SUBJECT: Facility-Wide Site Investigation and Remedial Action Plan
Enbridge Energy Superior Terminal, Superior, WI
WDNR BRRTS Activity #: 02-16-560657

On June 27, 2013, you requested that the Department of Natural Resources ("the Department") review and approve a Site Investigation and Response Action Plan, Proposed Risk-Based Site Wide Approach ("SI/RAP"), prepared by Barr Engineering. The purpose of the submittal is to provide the technical basis for a proposed negotiated agreement that would result in the use of a performance standard as a remedial action to address the groundwater pathway for releases at the Superior Terminal.

Figure 15

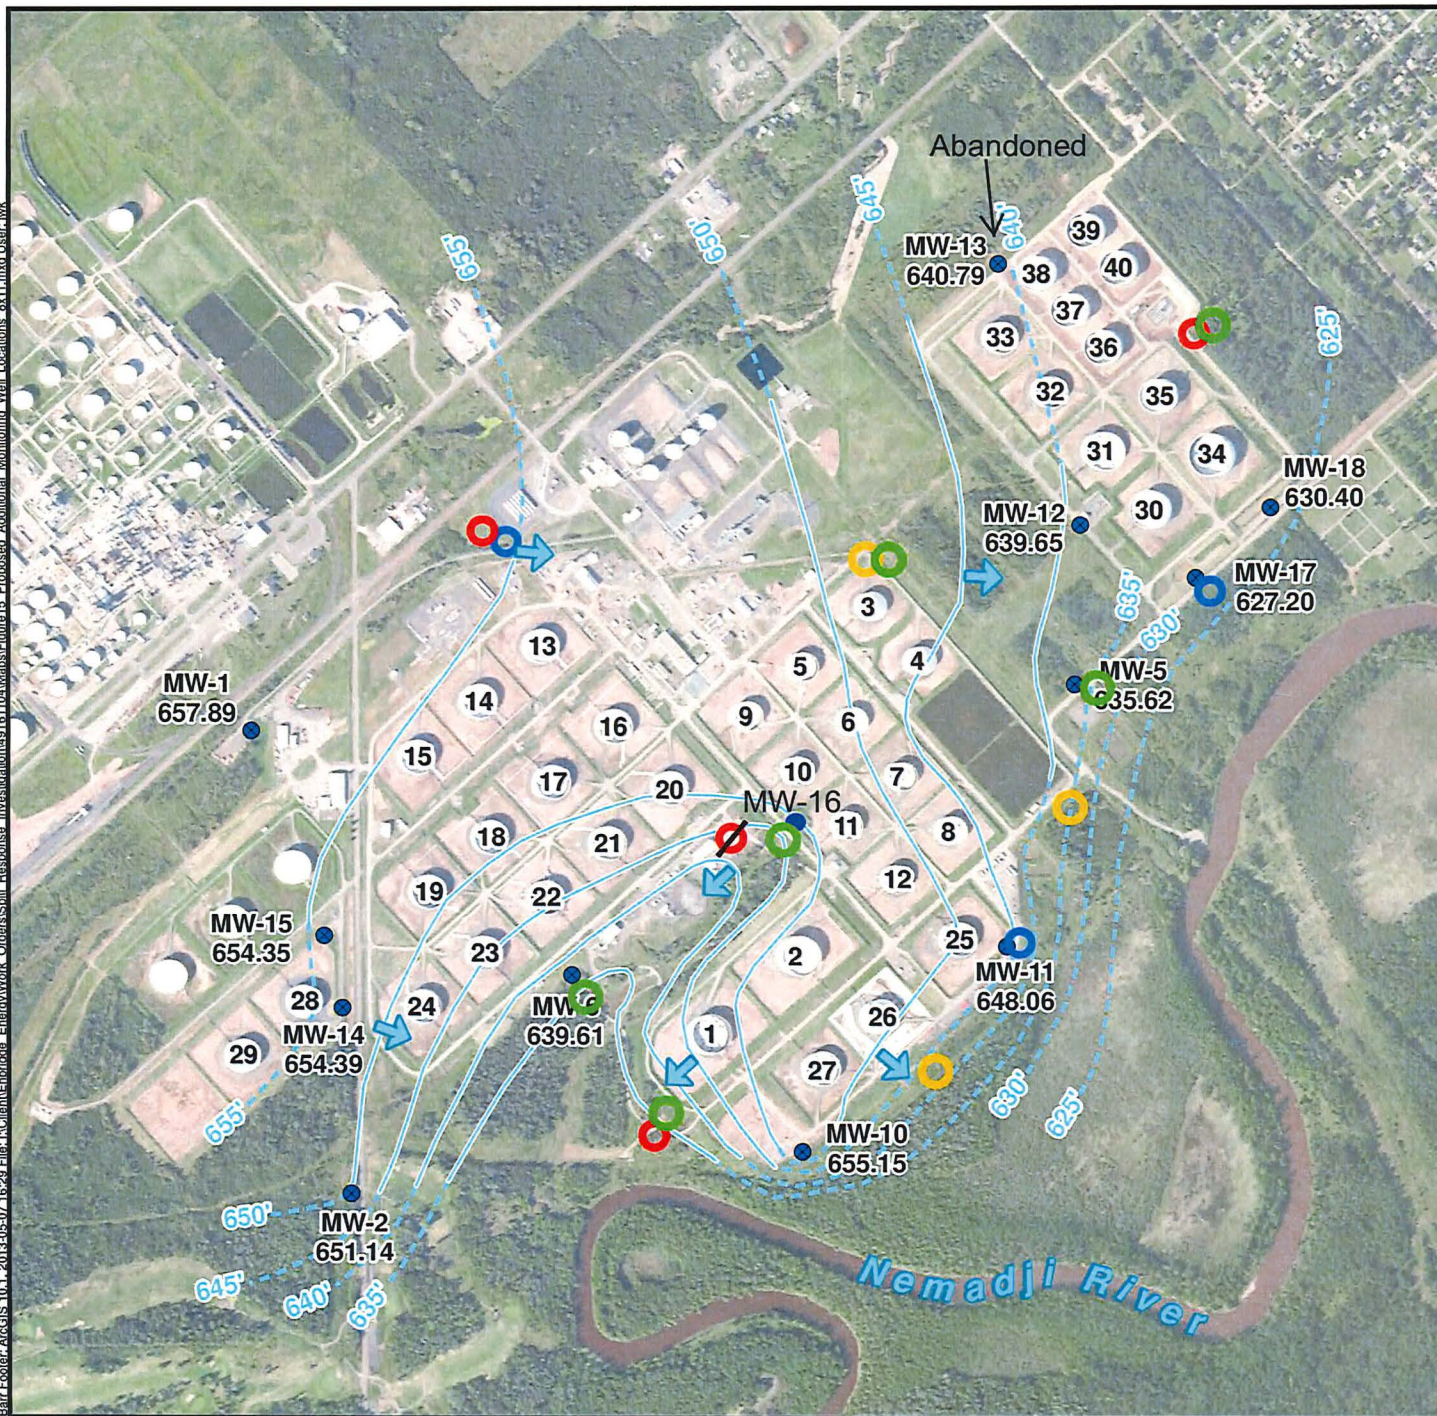
10. The Department approves the groundwater monitoring well network depicted in the attached figure, "Proposed Additional Monitoring Well Locations". We understand some of the wells were installed this year with the remainder of the wells to be installed in 2015. The SI/RAP approval is contingent upon all wells on the attached map being installed and sampled according to the Groundwater Monitoring Plan. Please submit all documentation required under NR141 Wis. Adm. Code for construction of the remaining wells to my attention at the letterhead address.

DNR Revisions

- proposed shallow well
- proposed piezometer
- ⊘ well not needed
